Product Change Notification

ARCOL are pleased to inform you of a technical specification change to the following product range.

Effected Part	: -HS200/HS250/HS300
Date Of Effective Change	: -January 2013
Type of Change	: -Phased in.

Previous Design

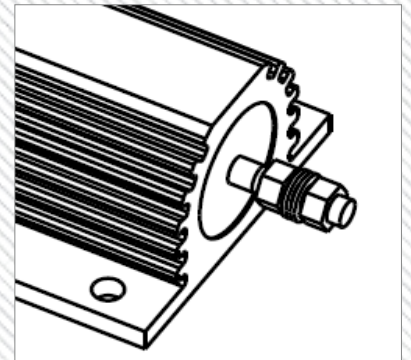
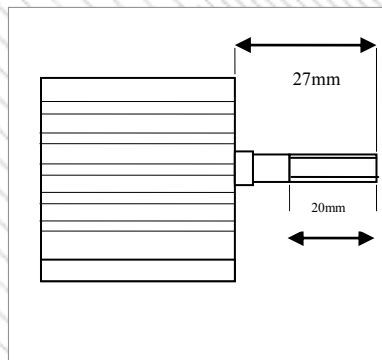
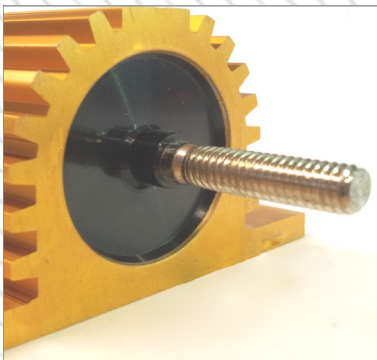
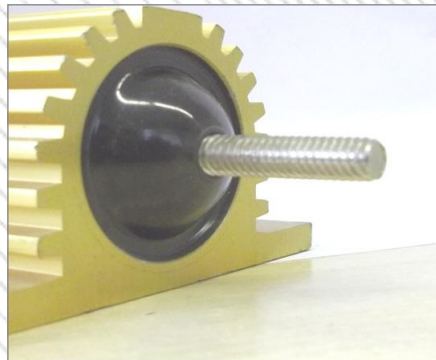
Due to continual product and process improvements the HS200, HS250 and HS300 have a new moulded end profile and improved terminal. This has been adapted to ensure no damage is occurred to the moulded surface whilst tightening of the nut which previously has caused failure in some product. The Photo's below show the new and old moulded ends and terminals for your comparison. The terminals and moulding are the only change to the product.
